UNITED STATES PATENT AND TRADEMARK OFFICE

APPLICATION NO.	FILING DATE	FIRST NAMED INVENTOR	ATTORNEY DOCKET NO.	CONFIRMATION NO
10/627,346	07/25/2003	Donald G. Gordy	DUR-104	2326
27014 7	590 05/18/2005		EXAMINER	
JOHN R. BENEFIEL 280 DAINES ST. #100 B			FERGUSON, MICHAEL P	
			ART UNIT	PAPER NUMBER
BIRMINGHAM, MI 48009			3679	
			DATE MAILED: 05/18/2009	5

DETAILED ACTION

As to claim 1, Liaw discloses an arrangement for connecting one end of a rod **A** (pins **A**, Figure 2 reprinted below with annotations) to a headed pin **5** to enable engagement of the pin with the rod, comprising:

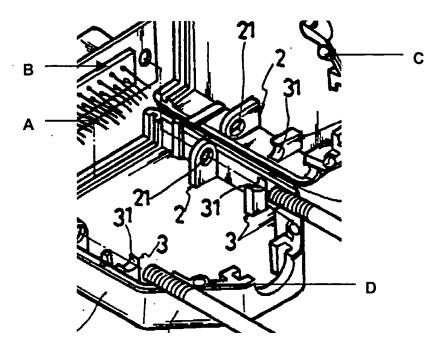
a housing 1 defining a pin receiving cavity formed therein with retention features 2,3 around the cavity engaging the headed pin so as to be retained therein;

a soft elastomeric isolator **B** (isolator **B** non-conductively isolates pins **A**) interposed between the housing and the one end of the rod;

the housing comprised of two pieces fit together and configured to enclose the isolator and also the one end of the rod, the two pieces joined together to form the housing (Figure 2).

As to claim 2, Liaw discloses an arrangement wherein the housing pieces 1 are joined together by snap fit prongs **C** on one housing piece received in receptacles **D** on the other piece (Figure 2).

As to claim 3, Liaw discloses an arrangement wherein the housing pieces 1 are molded as one part, the housing pieces connected together with an integral hinge 12 allowing the housing pieces to be swing together into abutment with each other and fit over the isolator **B** (Figure 2).

As to claim 4, Liaw discloses an arrangement wherein the housing pieces 1 each have a recess defined therein the recesses together forming a cavity when the housing pieces are assembled abutting each other enclosing the isolator **B** (Figure 2).

As to claim 9, Liaw discloses an arrangement wherein the housing piece isolator receiving cavity has an interference fit with the isolator **B** when the housing pieces **1** are assembled (Figure 2).
